PROJECT COMMENTS

PROJECT NUMBER: SP2022-045
PROJECT NAME: Site Plan for Alumni Bar & Grill
SITE ADDRESS/LOCATIONS: 906 S GOLIAD ST

CASE CAPTION: Discuss and consider a request by Allen Anderson of Adlor Enterprises, LLC for the approval of a Site Plan for a Restaurant on a 1.1308-acre parcel of land identified as Lot 1, Block B, Jack Canup Addition, City of Rockwall, Rockwall County, Texas, zoned Planned Development District 62 (PD-62) for General Retail (GR) District, addressed as 902 & 906 S. Goliad Street [SH-205], and take any action necessary.

LANDSCAPE PLAN

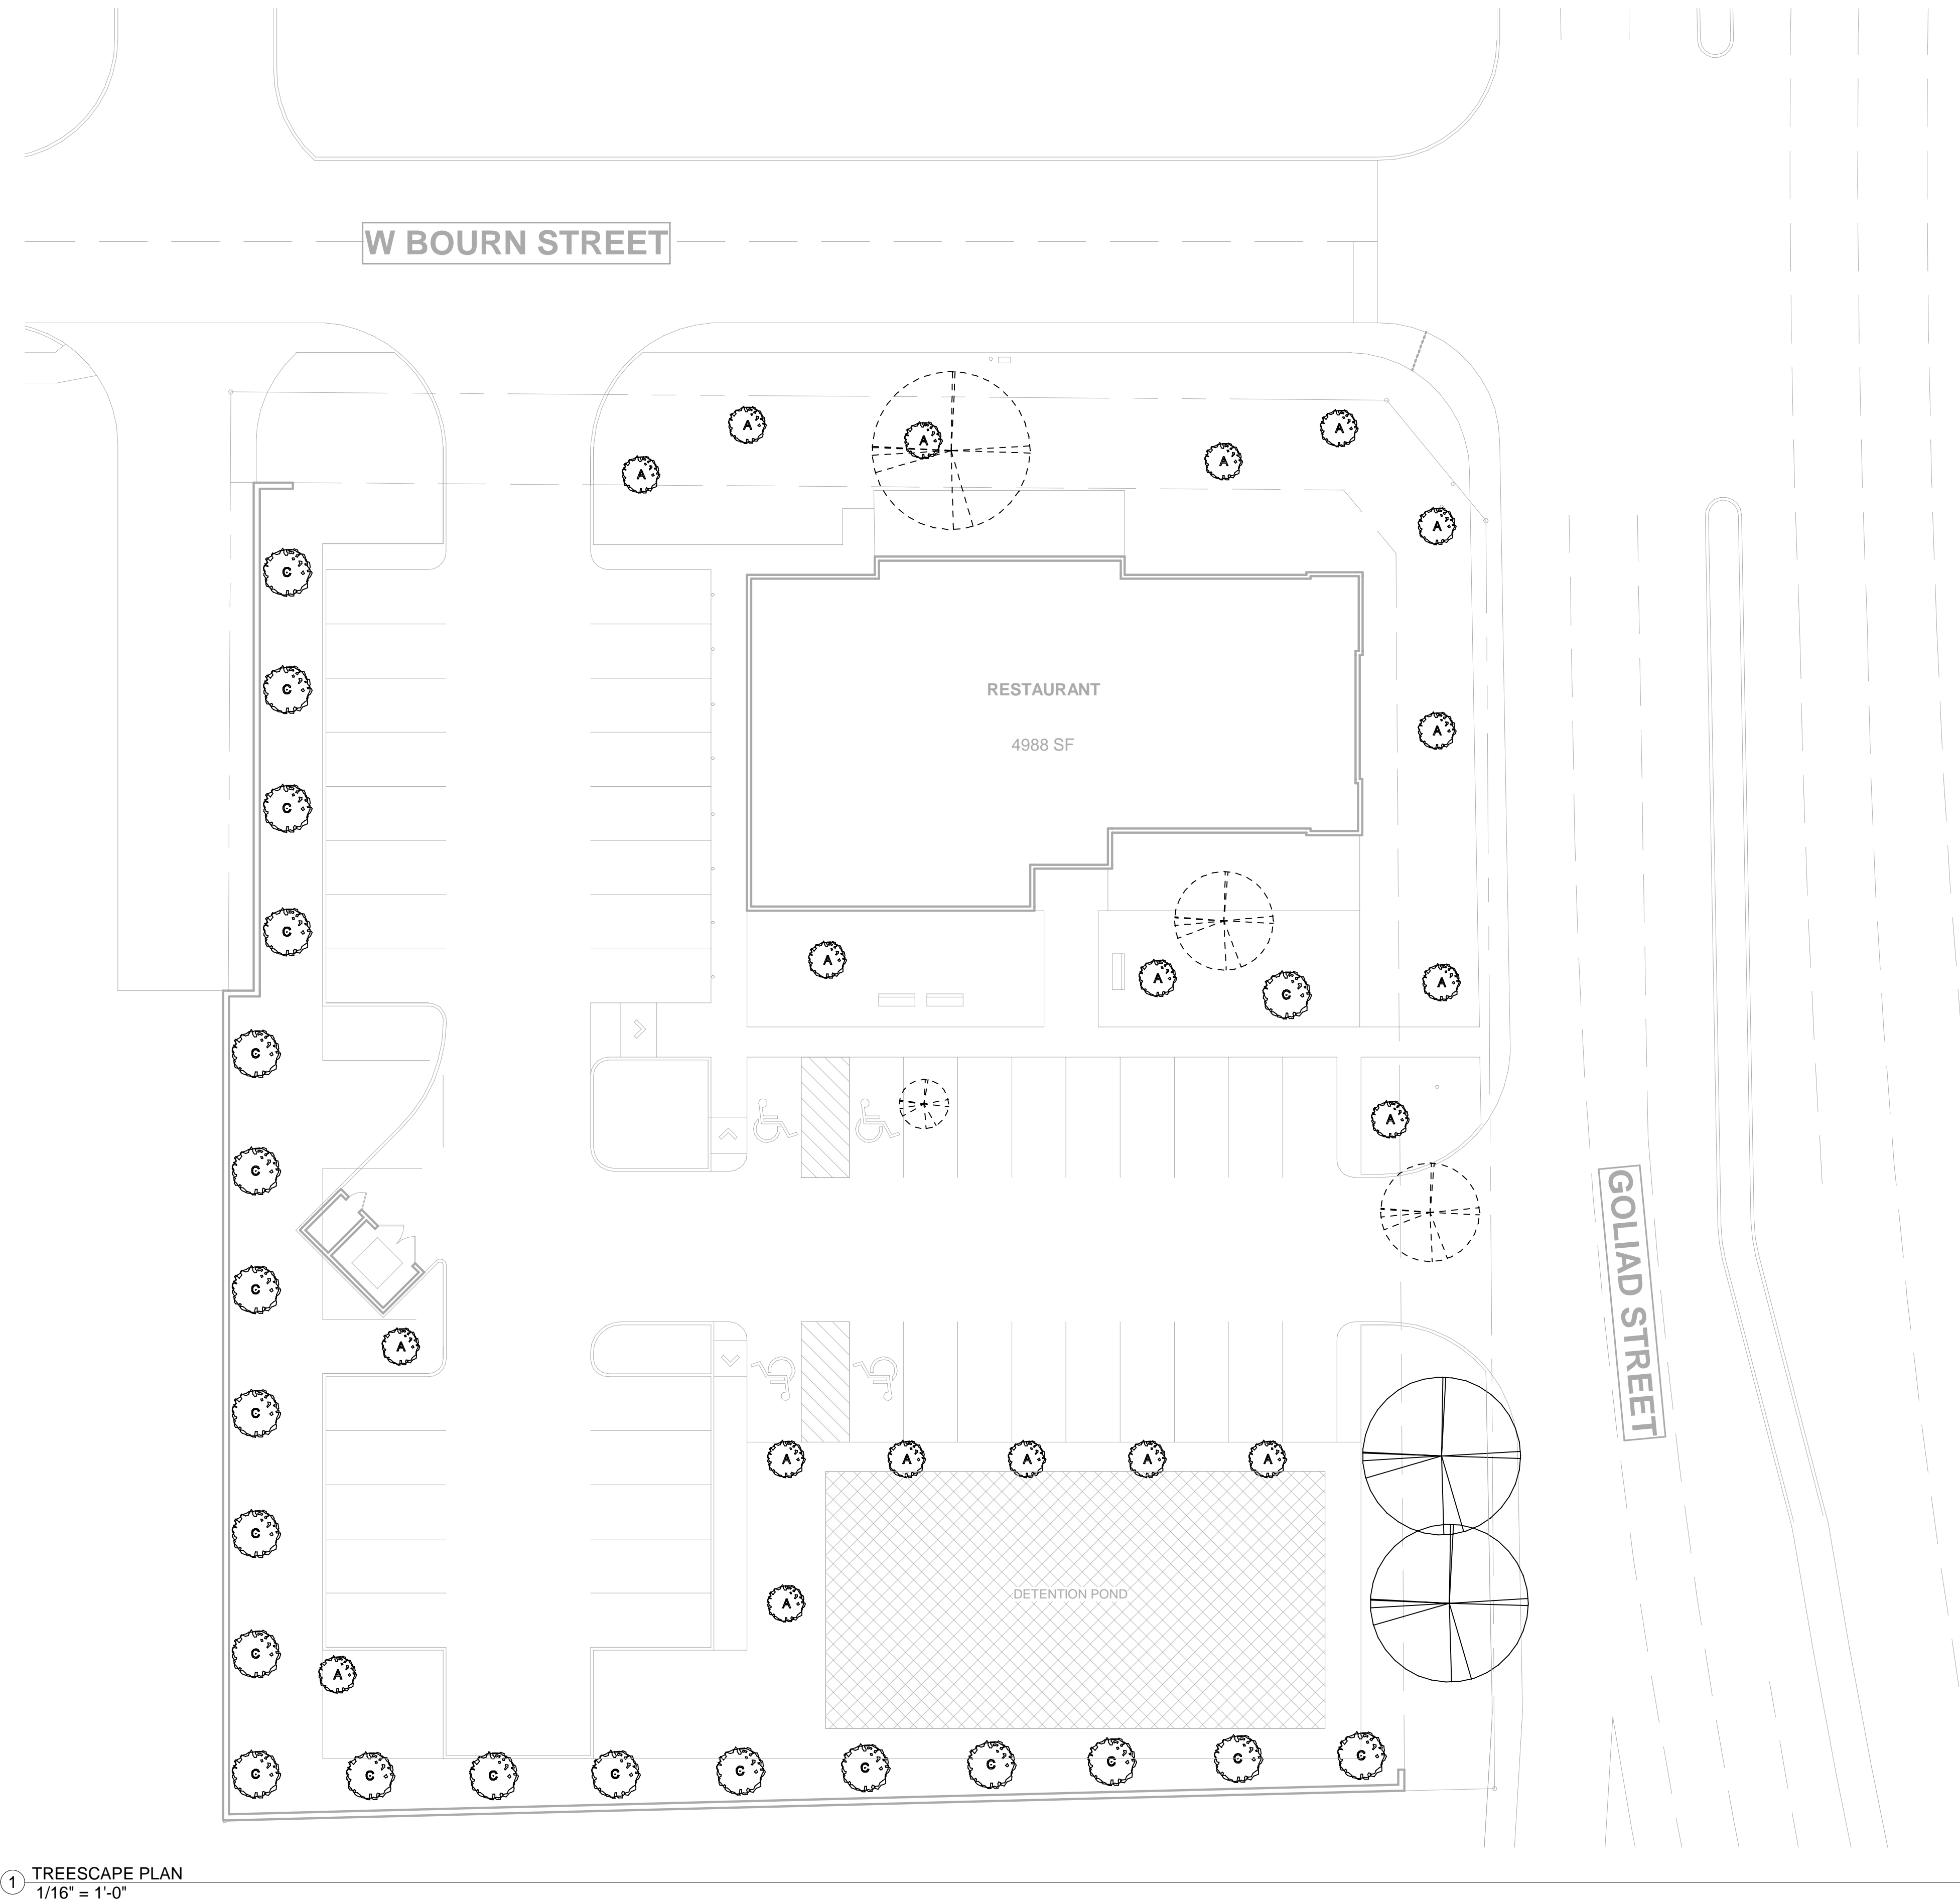
M.9 Landscape Plan:

1. Provide the same site data information required in Section 2.1 Site Plan: Miscellaneous and Density and Dimensional Requirements of this checklist. (See Section 2.1 of this checklist)

2. Provide the impervious vs. landscaped area within the site data table. (Subsection 01.01. B, of Article 05)
3. Within the landscape table provide the quantities of each plant and the size. Canopy trees must be 4 caliper inches, accent trees must be 4-feet tall, and shrubs must be 5 gallons. (Subsection 05.03. B, of Article 05)

4. Provide the required detention landscaping. There must be 1 canopy tree per 750 SF and 1 accent tree per 1,500 SF. (Subsection 05.03. B, of Article 05)

5. Identify the visibility triangles for both driveway intersections. (Subsection 01.08, of Article 05)
6. Clearly indicate and delineate the landscape buffer around the property, and indicate the berm along W. Bourn Street and S. Goliad Street. (Subsection 05.01, of Article 08)

7. Are you requesting a variance to the landscape buffer requirements? The landscape buffers along the roadways require 1 canopy tree and 1 accent tree per 50 linear feet of frontage. If you are requesting a variance to not plant the canopy trees I will need a variance letter.

08/22/2022: Landscape Plan:

Need to show tree sizes on plant legend

Canopy 4" minimum

Ornamental / Accent 4' height minimum

TREESCAPE PLAN

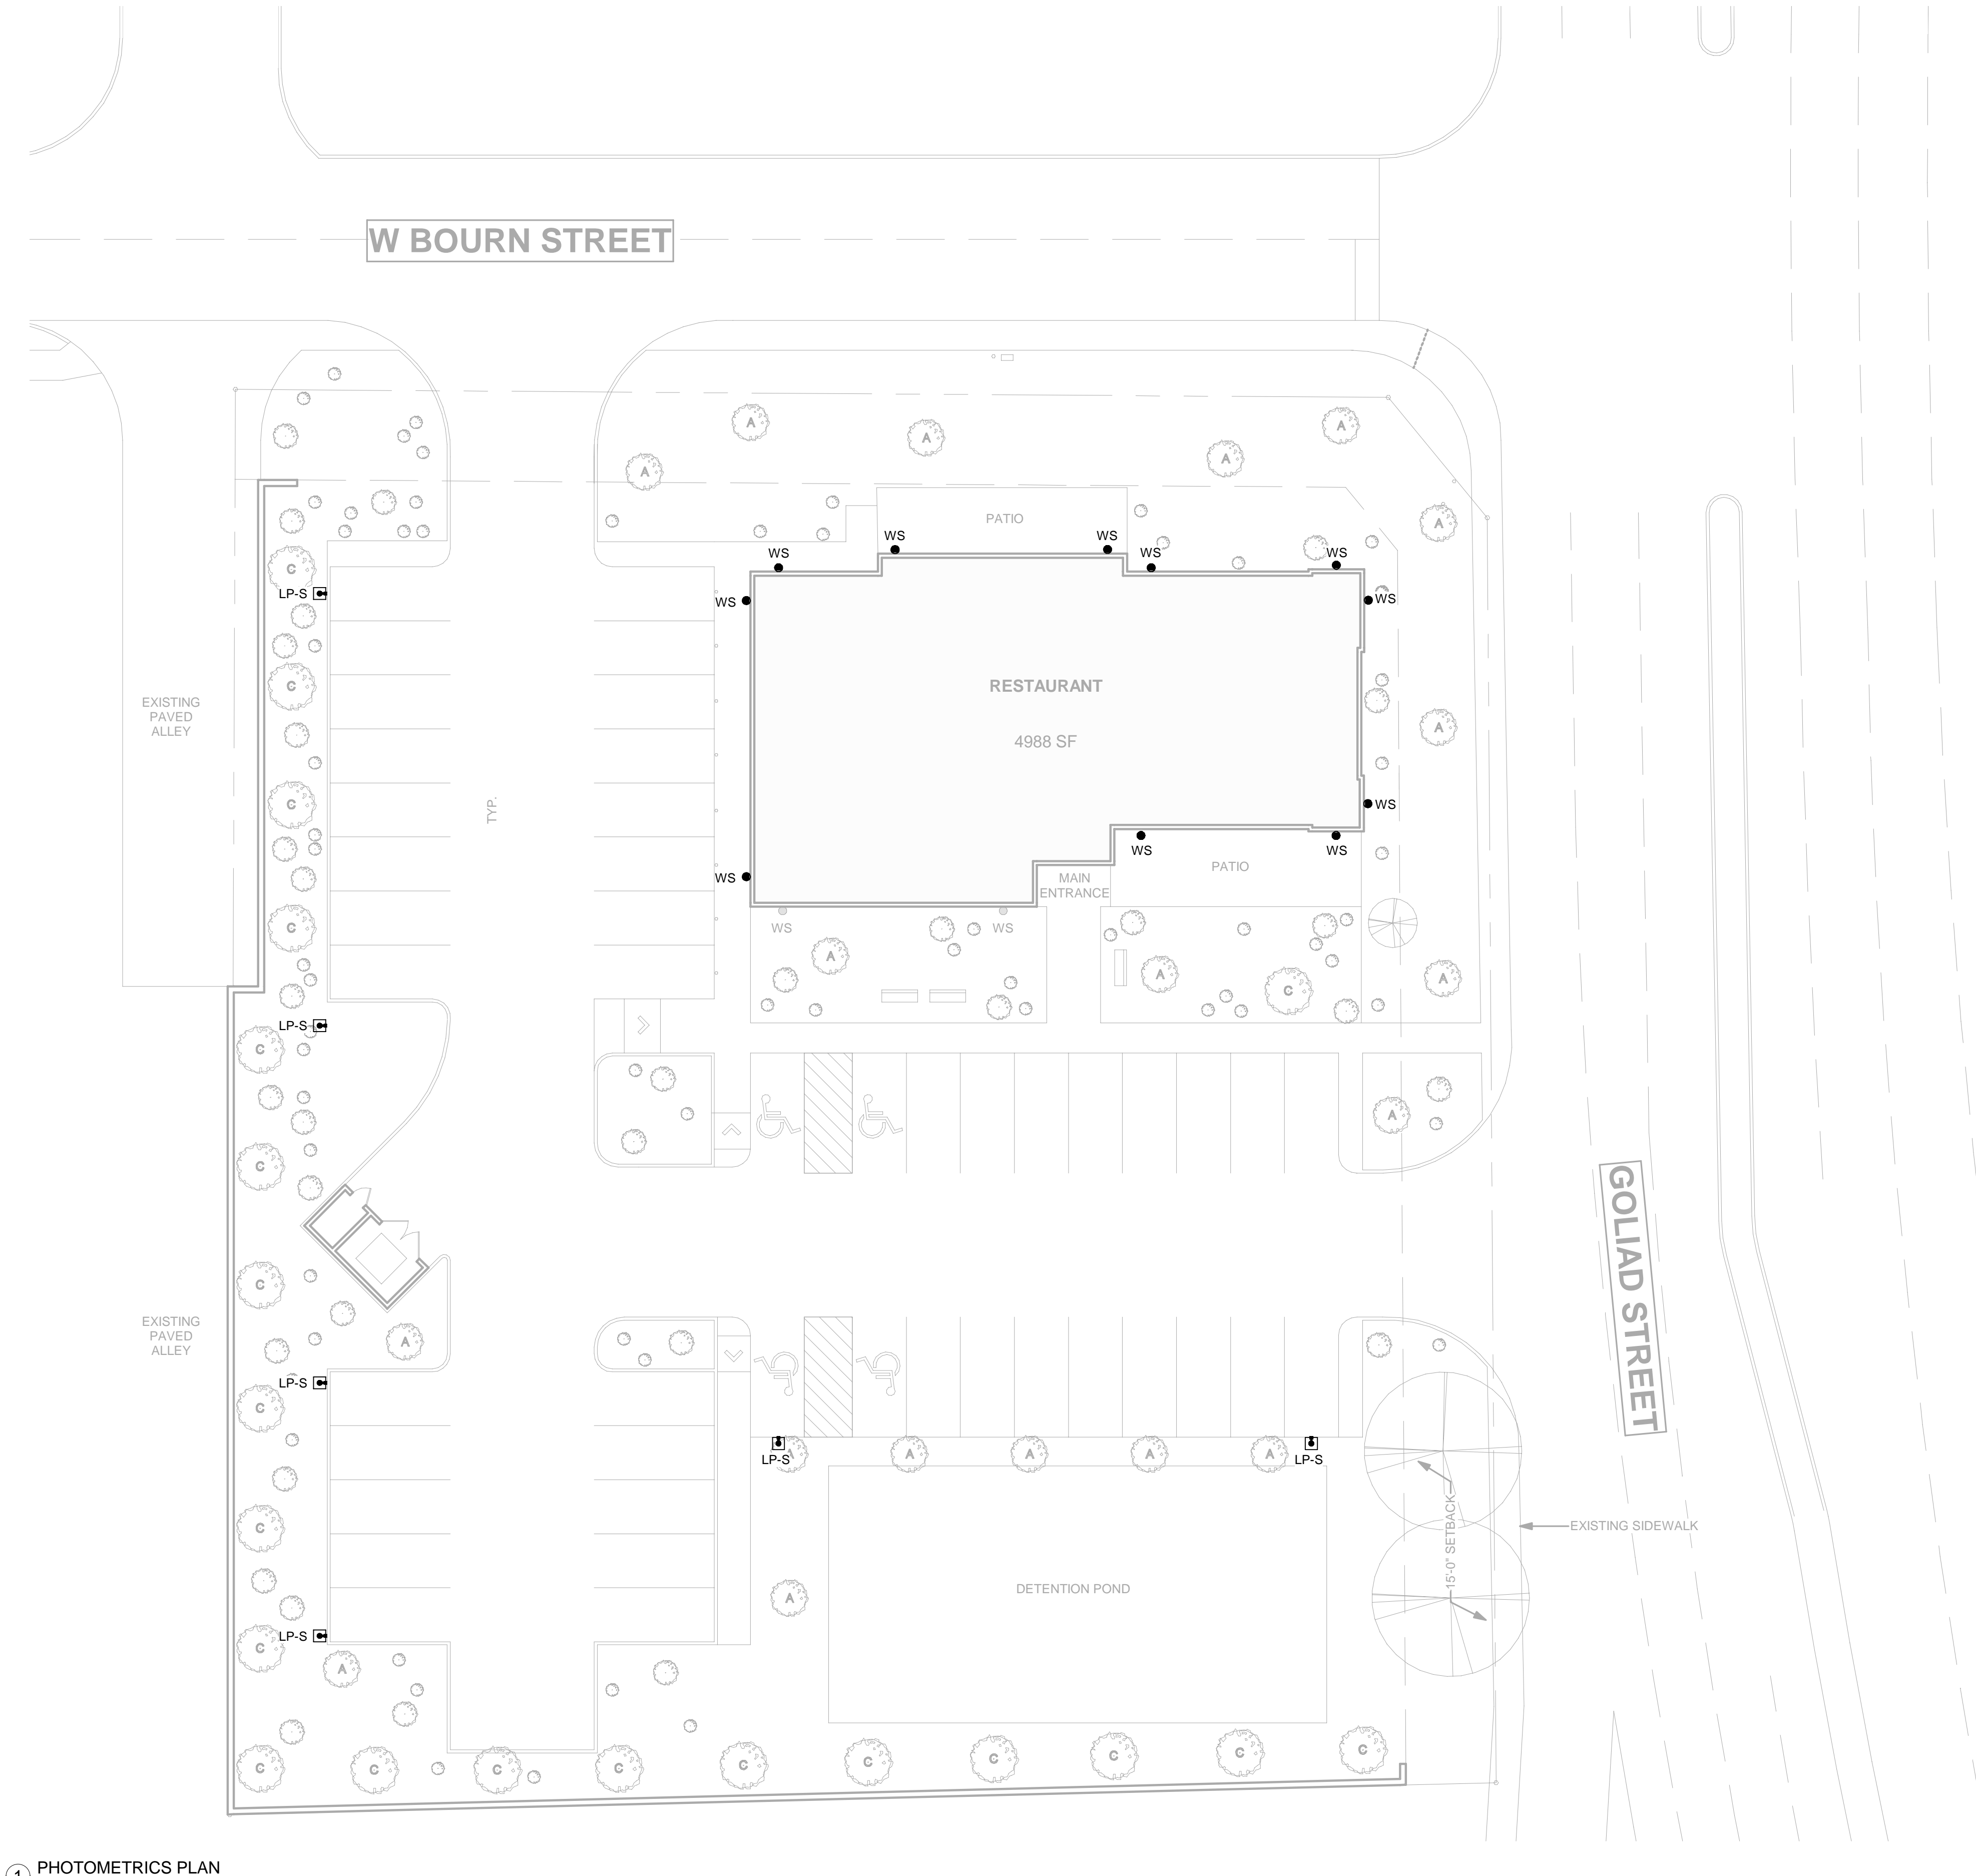
M.10 Treescape Plan:

1. Provide the same site data information required in Section 2.1 Site Plan: Miscellaneous and Density and Dimensional Requirements of this checklist. (See Section 2.1 of this checklist)
2. Provide a Treescape table that indicates the sizes of the trees on the subject property. (Subsection 03.01. G, of Article 09)

Please provide a tree mitigation plan on trees being removed.
species, caliper health
